CDM Project File: 27355-47930, 5.2

Subject: Notification of Deviations to Pre-Remediation Work Plan  
Extraction, Injection, and Observation Well Installation  
Boeing Realty Corporation, Former C-6 Facility  
19503 South Normandie Avenue  
Los Angeles, California  
SLIC # 410

**Figure 2**  
**Boeing Realty Corporation**  
**Former C-6 Facility**  
**Proposed C-Sand**  
**Extraction and Injection Wells**

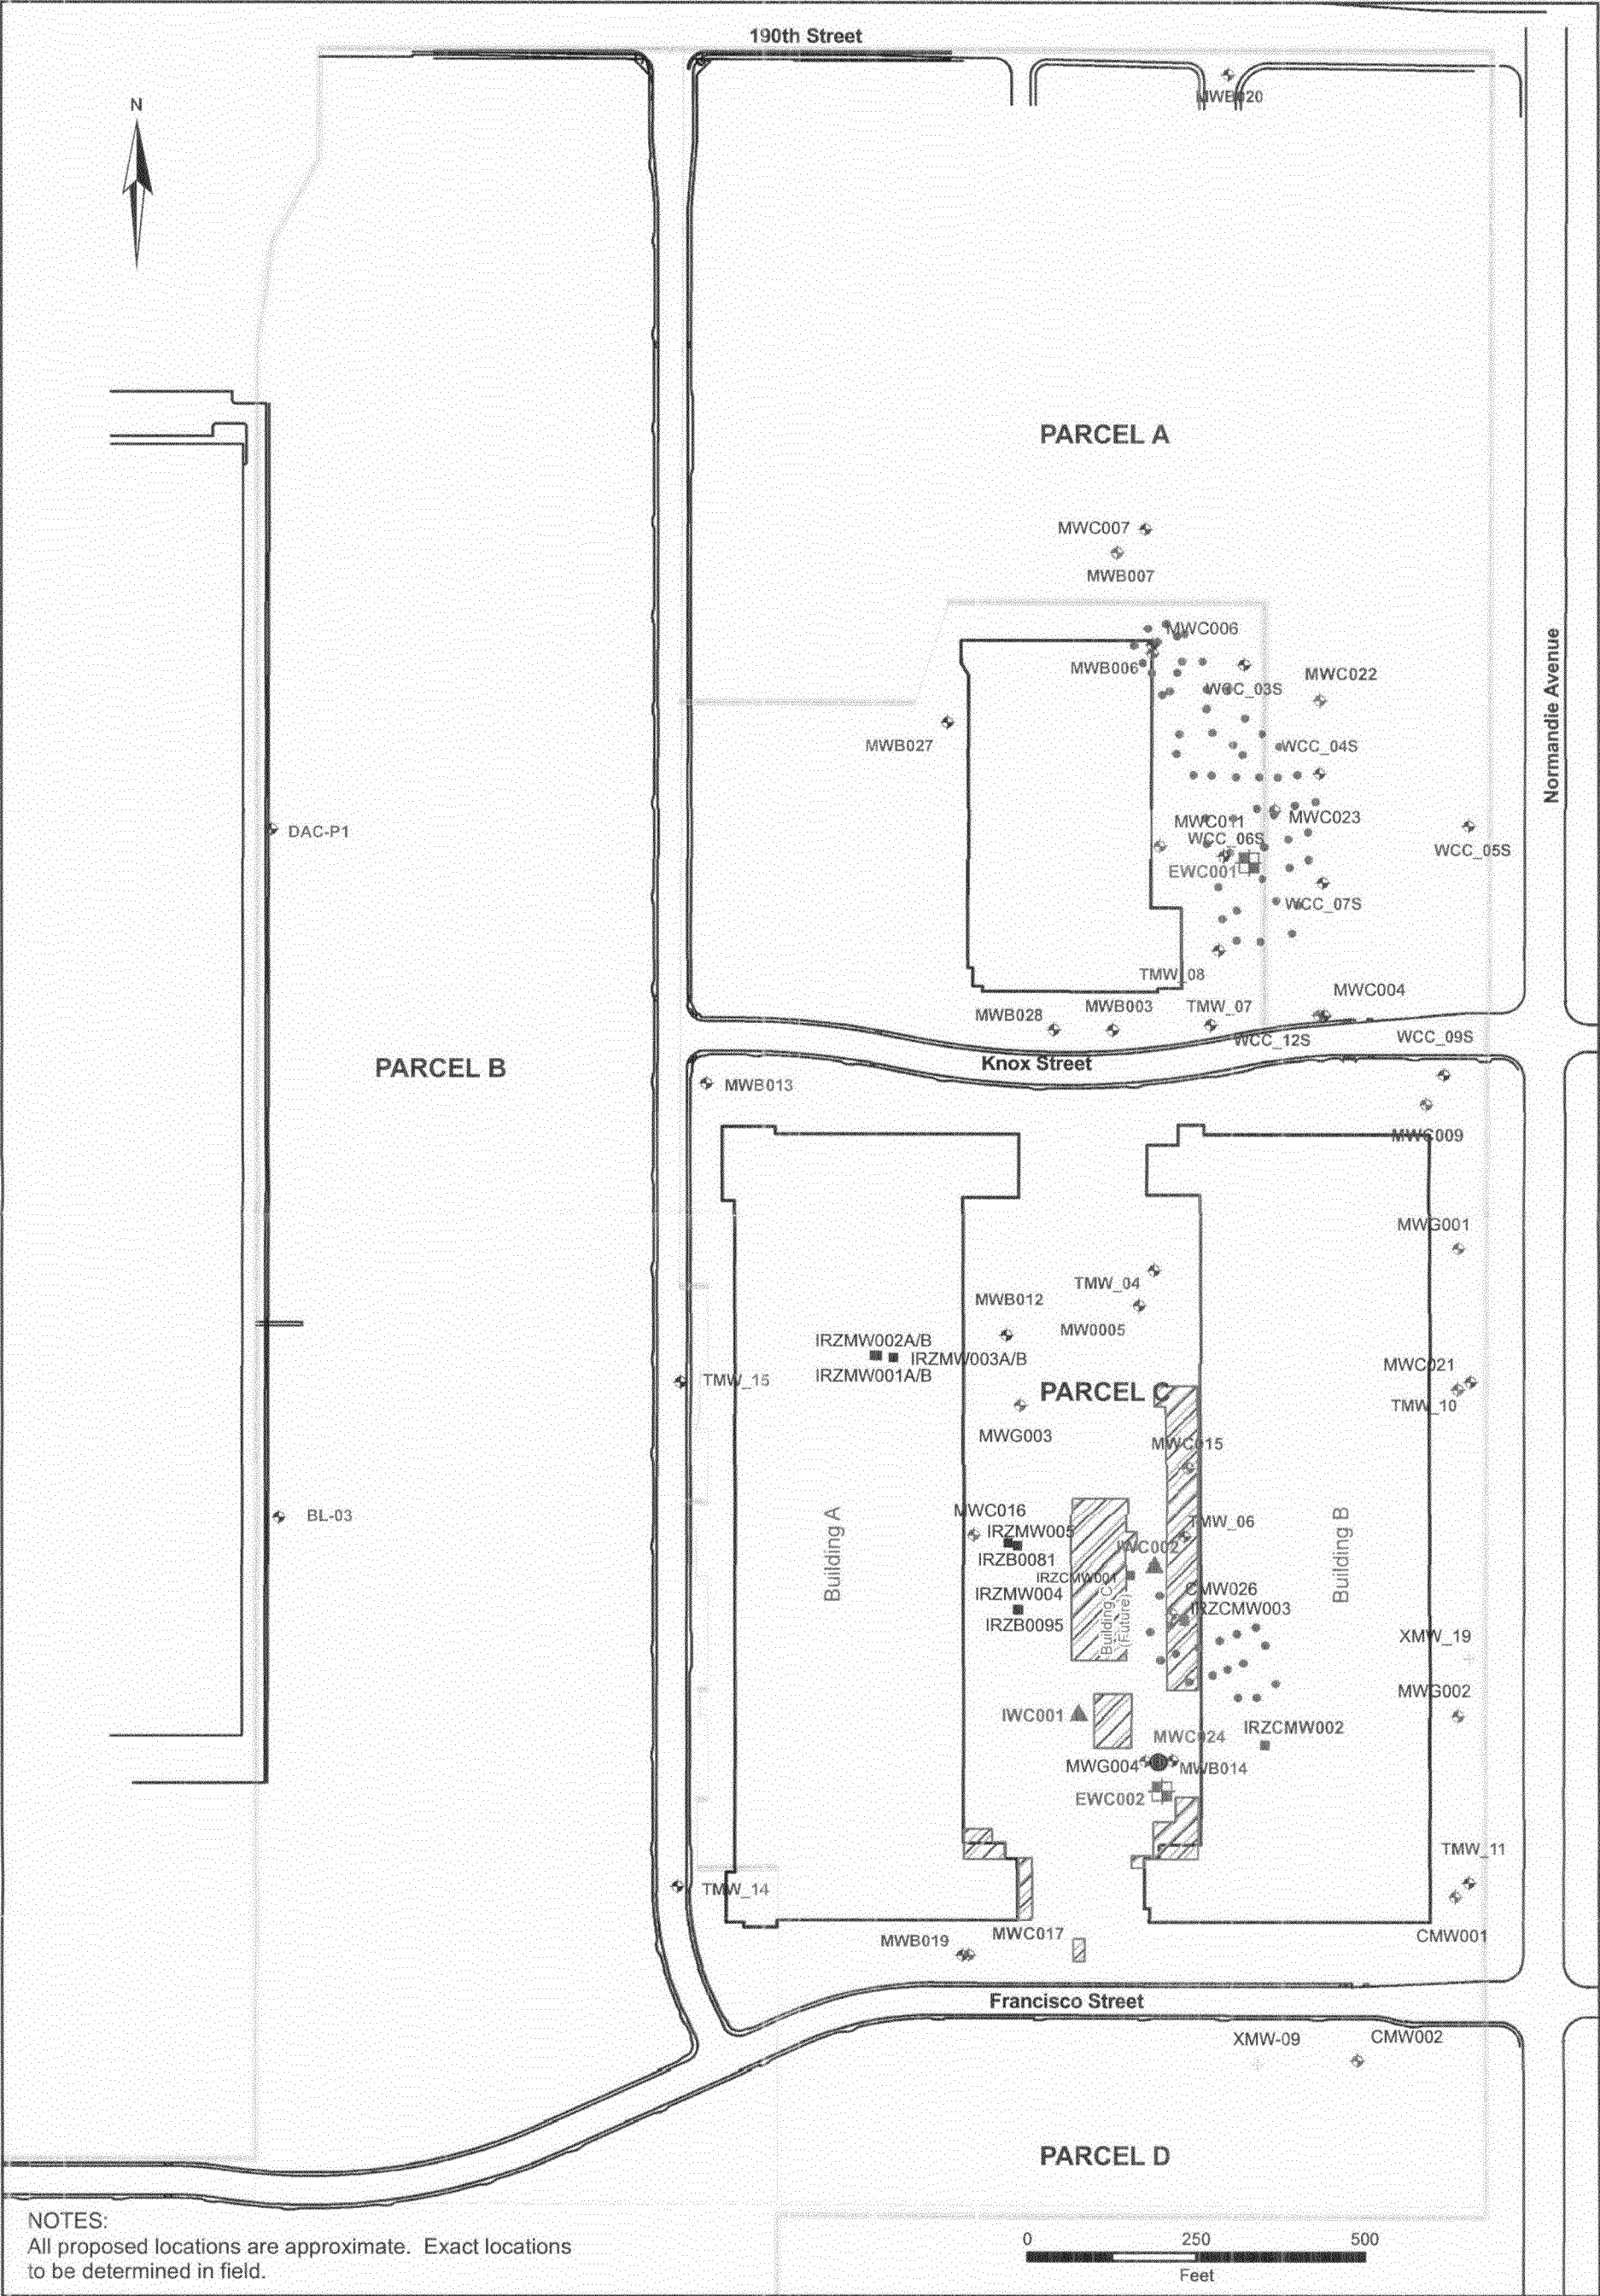
- Two extraction wells (one B-Sand and one C-sand) are proposed in the northern parcel (Lot 8) as shown on Figure 1, instead of the one well (B-Sand only) originally proposed in the Work Plan. In addition, no aquifer testing is planned for Lot 8 as adequate historical data appear to be present. We anticipate that these changes will facilitate the future implementation of groundwater remediation at the parcel.
- Two injection wells are proposed in the southern parcel (Sunrider Property) as shown on Figure 2 in order to replace/augment the existing injection infrastructure due to concerns regarding the effectiveness of the existing infrastructure. In addition, one observation well is also proposed (Figure 2) to allow for groundwater monitoring during the C-Sand aquifer testing.
